## **ADDENDUM NO. 6**

**City of Suffolk**  
**IFB #20050-AG**  
March 12, 2020

### **Joint Operations Facility (Police/Parks & Recreation)**

SKETCH NUMBER  
SKA-602A

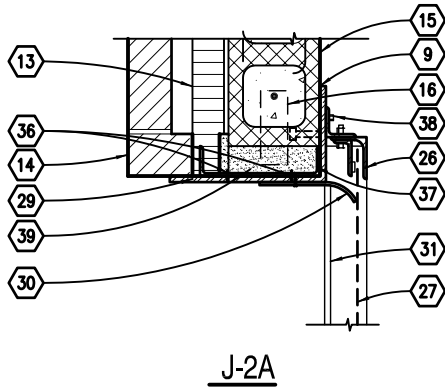
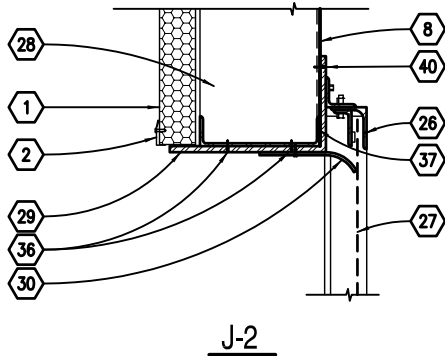
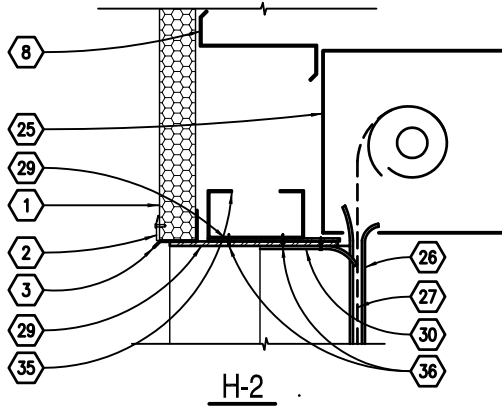
Please refer to note 29 on A-602. This note is pointing to a steel plate on the jambs of detail J-2, J-2A and H-2 and states to refer to the structural drawings for the size. However the structural drawings do not show the size or details of the plate. Please provide the size, thickness and stud spacing of the steel plate to be installed at the jambs.

Please refer to detail H-2 on A-602. Note 24 states to refer to the structural drawings for the lintel. Please note that the structural drawings do not show a lintel or provide a the locations of the lintel. Please provide a size and location of the lintels. Please note that the pre-engineered metal building suppliers usually do not provide the lintels.

See **Sketch SKA-602A dated 3.13.20** for changed to the door details that will address this concern.

See **Sketch SKA-602A dated 3.13.20** for changed to the door details that will address this concern.

THIS SKETCH MODIFIES SHEET A-602
